Cordillera Valley Club

Design Review Board

Cordillera Valley Club Design Review Board *Staff Memorandum*

Owner: David Bloch
Address: 94 Juniper Lane
Legal Address: F1 L18
Architect: Adam Harrison, Shephard Resources Inc.
Staff Contact: Allison Kent, AICP
DRB Hearing #1: January 22, 2025

E-001

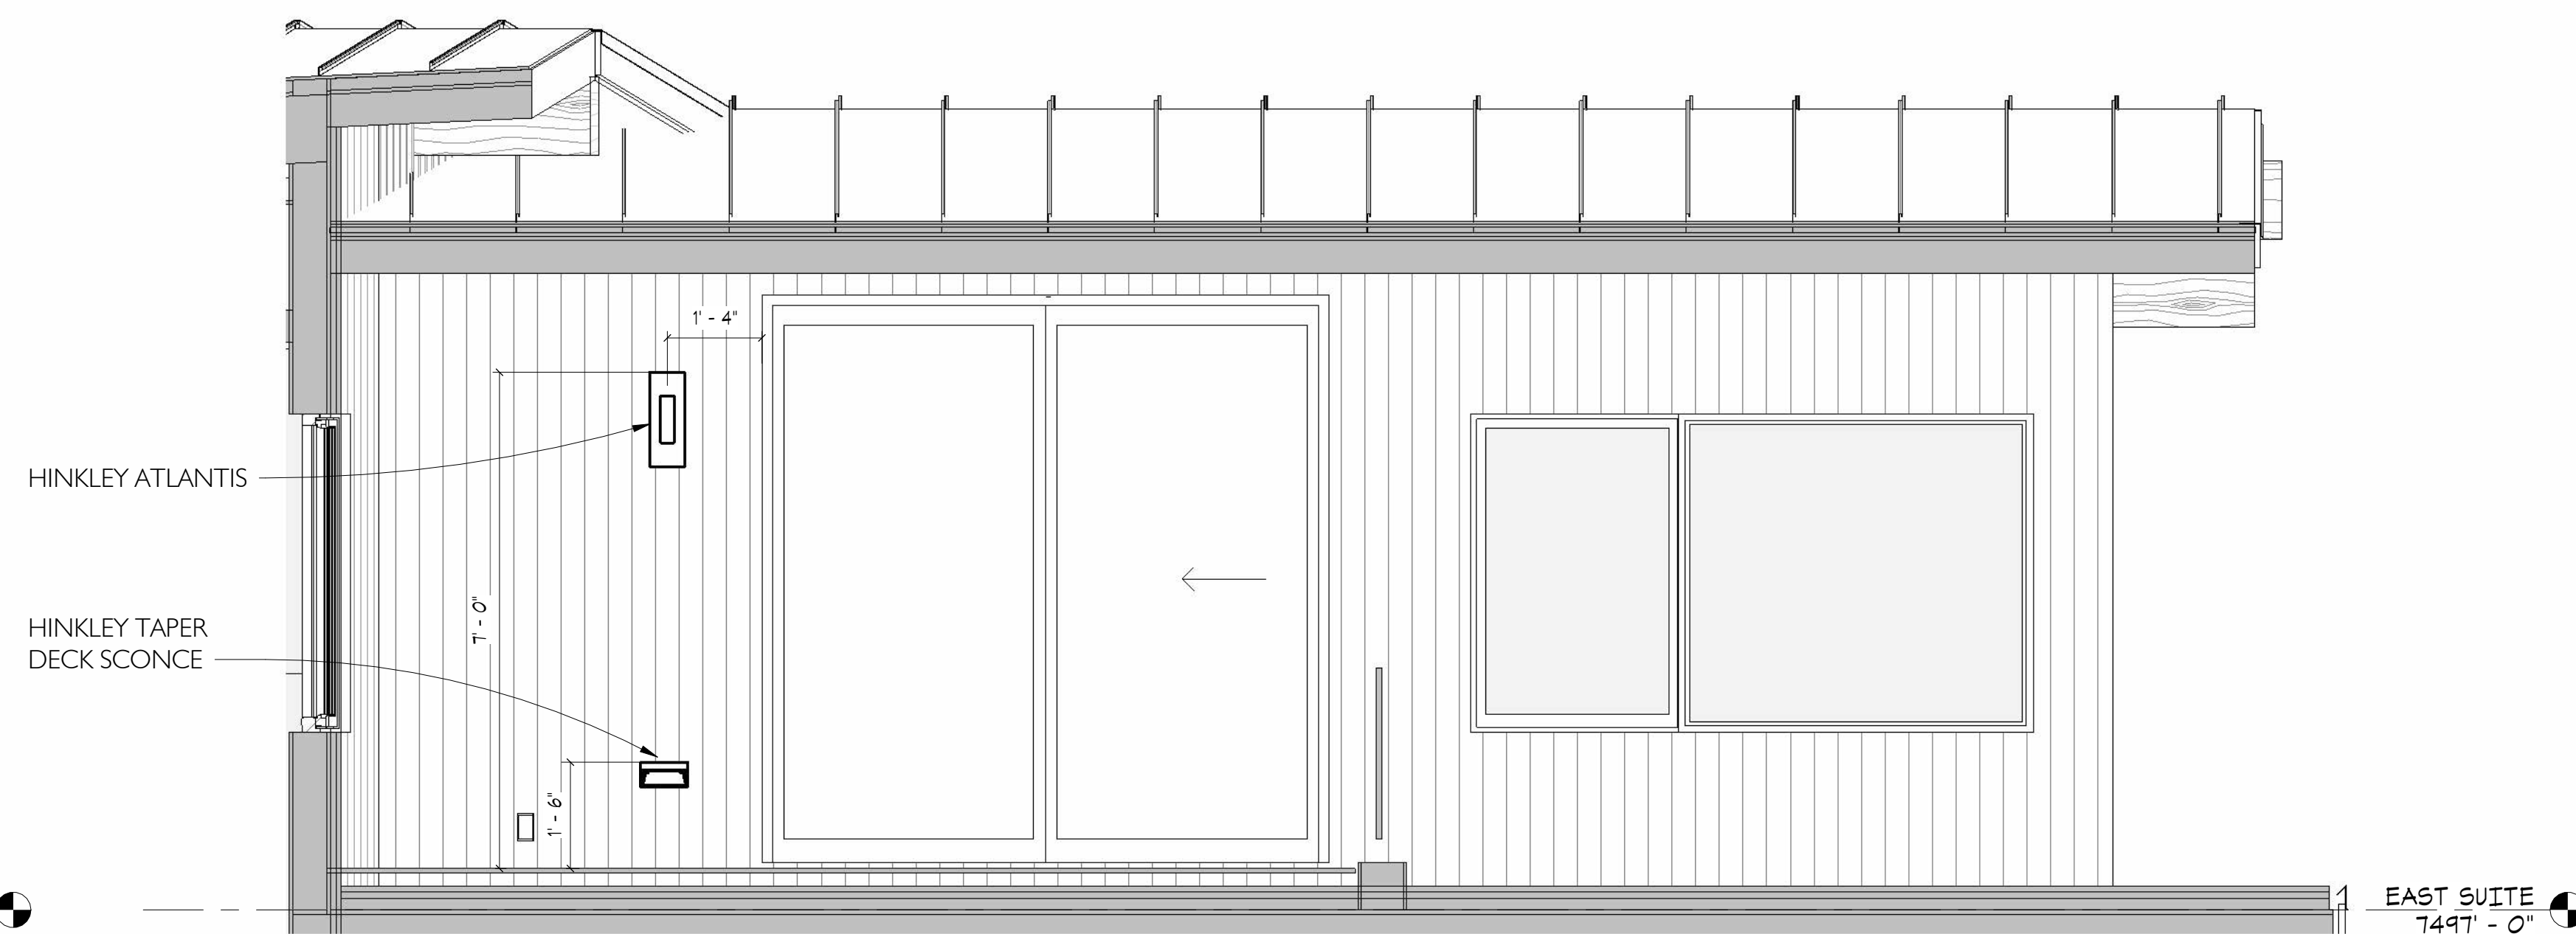
1. The proposed addition is located above an existing flat roofed area. As a result, there is no change to the existing footprint of the home.
2. The applicant has indicated two light fixtures for the exterior of the home. The "Taper Deck Sconce" is not dark sky compliant. This fixture is not permitted. It can be replaced with one that is dark sky compliance or must be removed from the plan set prior to Technical Plan review.
3. The plans show no new roof or wall vent or mechanical penetrations with the addition. If there are any new roof or wall mechanical penetrations, they must be indicated on the Technical Plan set. All venting and penetrations must be painted to match.
4. The proposed addition meets all other standards, including the height limitation and the stone minimum.

1. The applicant shall address the comments provided in this staff memorandum and any DRB comments prior to technical review.
2. All materials and colors to match existing.
3. Prior to Technical Review, the applicant shall provide light fixture cut sheets indicating that all fixtures are dark sky compliant. The Taper Deck Sconce 15635K does not indicate that it is dark sky compliant and is therefore not approved for use.

1 PROPOSED SITE PLAN - ENCROACHMENT
1" = 10'-0"

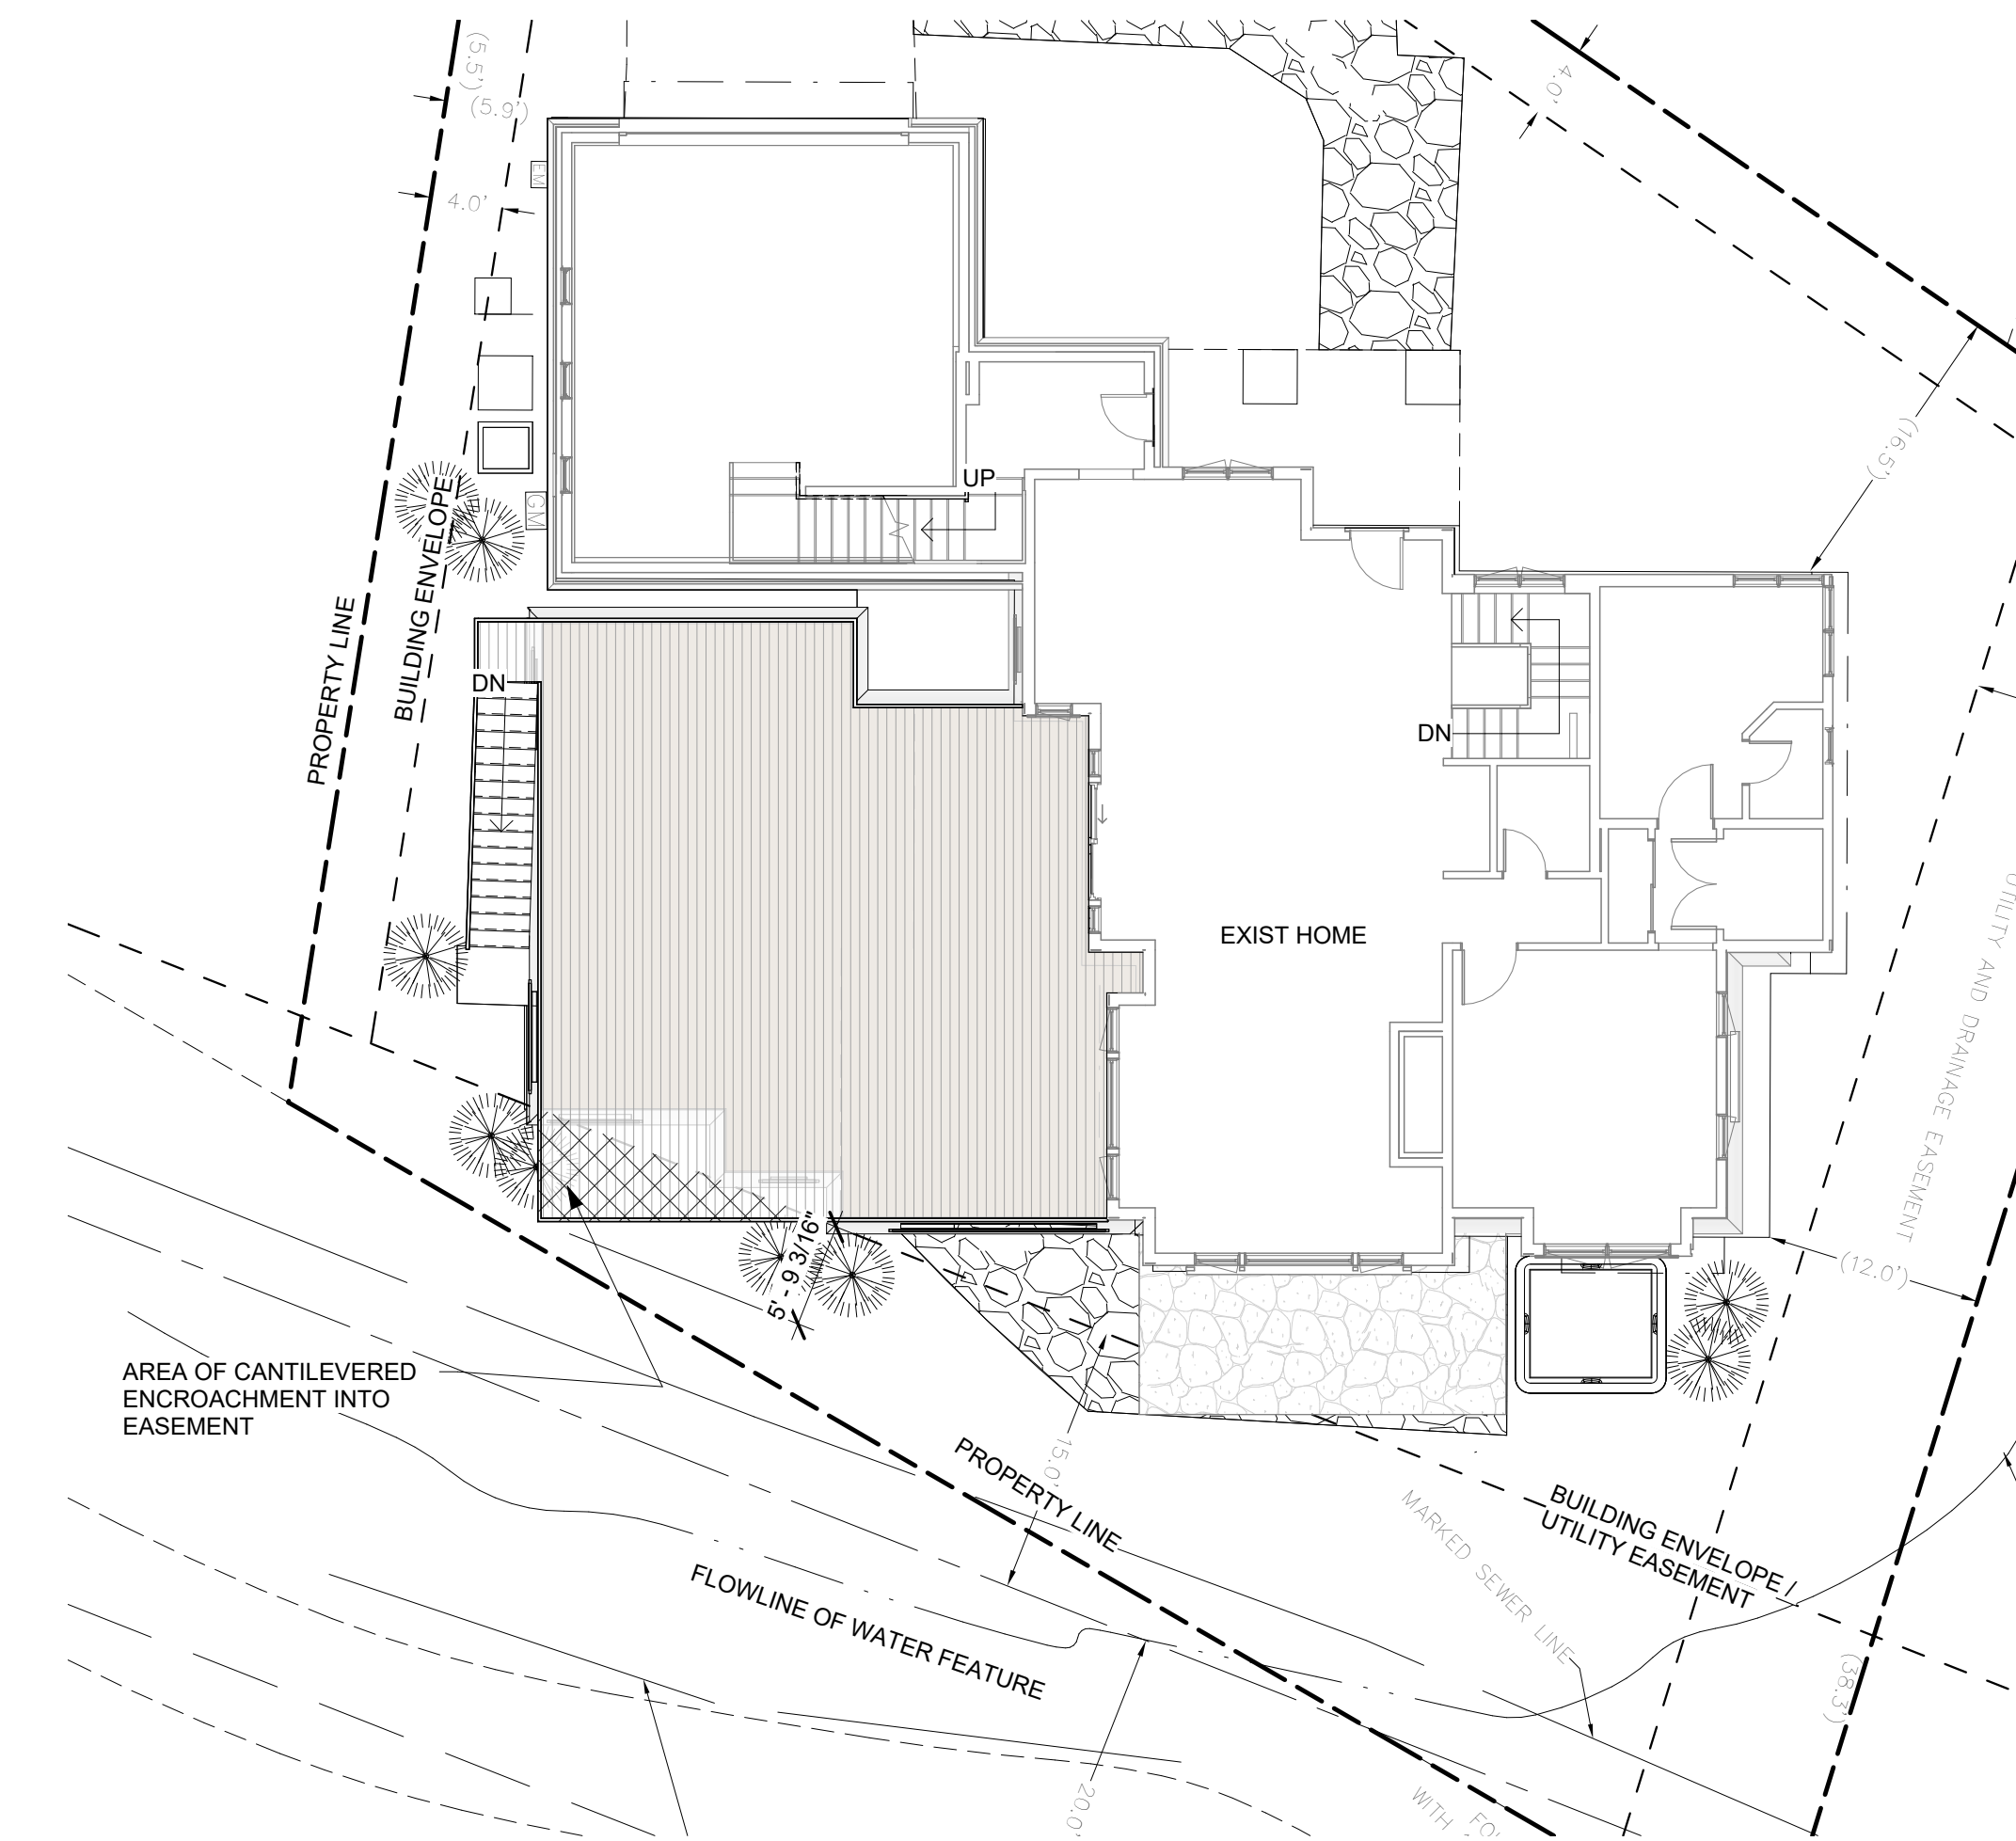
3. The proposed deck is located in a water and sewer utility easement. The applicant has provided confirmation from ERWSD that they will approve the encroachment into the easement following DRB approval. The encroachment agreement must be provided to staff prior to Technical Plan approval.

5. Prior to the refund of the compliance deposit, an ILC must be submitted to staff demonstrating compliance with the approved plans.
6. The proposed deck is located in a water and sewer utility easement. The applicant has provided confirmation from ERWSD that they will approve the encroachment into the easement following DRB approval. The encroachment agreement must be provided to staff prior to Technical Plan approval
